RESPONSE TO REQUEST FOR ADDITIONAL INFO. ON DESIGN CRITERIA FOR
STRUCTURES, COMPONENTS, EQUIPMENT, & SYSTEMS INCLUDED IN AMEND. NO.
50.

PLANT NAME: DIABLO CANYON - UNIT 1
DIABLO CANYON - UNIT 2

Re: Docket No. 50-275-OL
Docket No. 50-323-OL
Diablo Canyon Units 1 & 2

The enclosure to your letter dated August 24, 1977 included a series of questions covering additional information on design criteria for structures, components, equipment, and systems included in Amendment No. 50. Enclosed are 20 copies of the answer to Question 3.67A(d). The answer was inadvertently omitted from our response dated November 2, 1977. Also enclosed are updated and expanded responses to Questions 3.54, 3.67A, and 3.98.

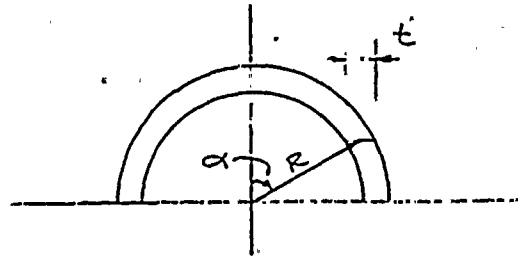
- (d) How were the torsional stiffnesses in the coupled analysis computed?

In the dome section equation (2) becomes

$$\phi = \int_{\alpha_1}^{\alpha_2} - \frac{TR \sin \alpha d\alpha}{2\pi(R^3 \sin^3 \alpha) \frac{2.5}{\sin \alpha} G} d\alpha$$

where α and R are as shown below:
